May 4, 2016

ADDENDUM #1

IFB 16-21 PARK & LOCUST STREETS – MINI ROUNDABOUT

Pavement Marking Plan

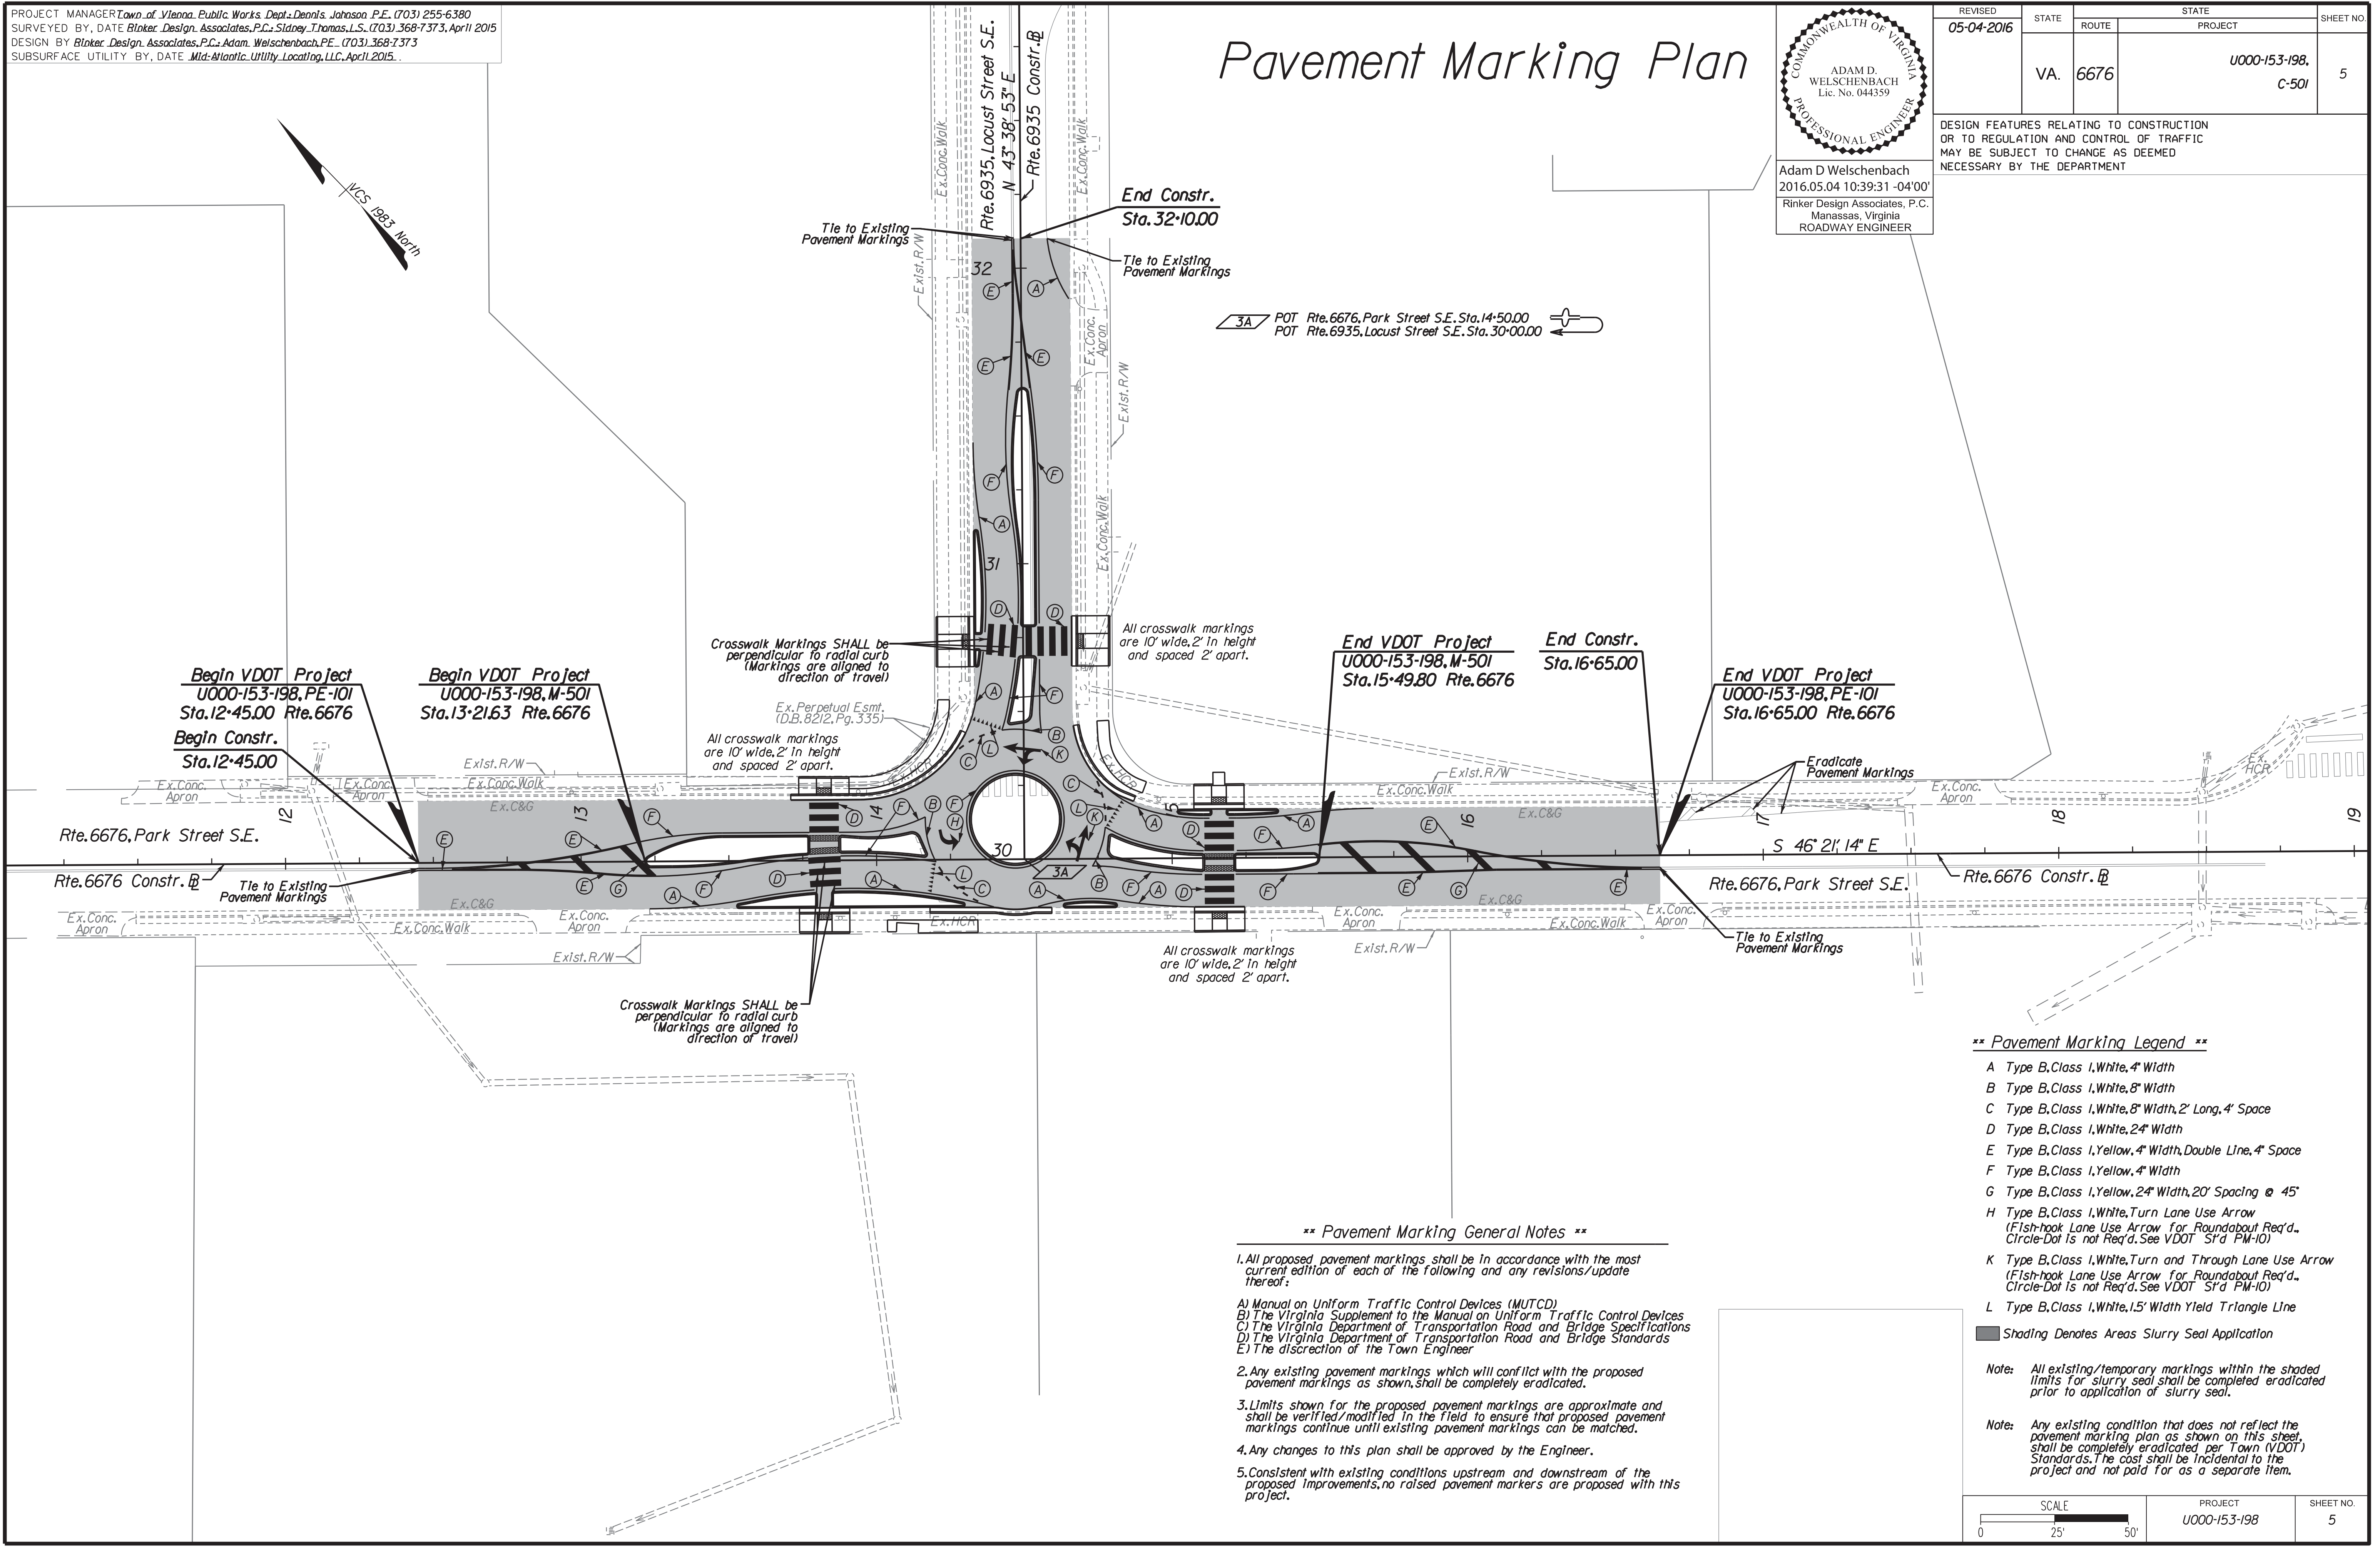
1. Q: Line items 34, 35 and 36 on the bid sheet call for Type B, Class VI Tape, with Thermo-Plastic in parentheses; thermo-plastic is Type B, Class I. Please verify which material the Town intends to use for this project.
A: It should be Type B Class I (Thermo-Plastic). A revised Bid Form is attached.]
2. Q: Are the Arrows Round-About Arrows or standard? There is a considerable difference in pricing as the Round-About Arrows will have to be Type B Cl II(Preformed Thermo).
A: Fish-Hook Arrows (Roundabout Arrows) with Type B Class I markings.

Revision	Date	Description
REVISION DATA INFORMATION		
03-01-2016		The following changes were made by Adam Welschenbach at the request of the Town of Vienna to clarify the duration of the Detour the Contractor is to Implement for construction of the project's Improvements.
		Sheet 1B - Revision Data Information Added
		Sheet 1J - Note 1C was revised to explain Detour duration limitations
		Sheet 1J(1) - Phase 1 was updated to clarify duration. All VWAPM TTC references were updated.
		Sheet 3 - Reference to landscaping location added.
05-04-2016		The following changes were made by Adam Welschenbach at the request of the Town of Vienna to clarify the type of pavement markings to be installed for the project.
		Sheet 5 - Lane Use Arrows were revised to reflect they should be fish-hook style for roundabouts per VDOT's Std. PM-10

- H Type B, Class I, White, Turn Lane Use Arrow (Fish-hook Lane Use Arrow for Roundabout Req'd, Circle-Dot is not Req'd. See VDOT Std PM-10)
 - K Type B, Class I, White, Turn and Through Lane Use Arrow (Fish-hook Lane Use Arrow for Roundabout Req'd, Circle-Dot is not Req'd. See VDOT Std PM-10)
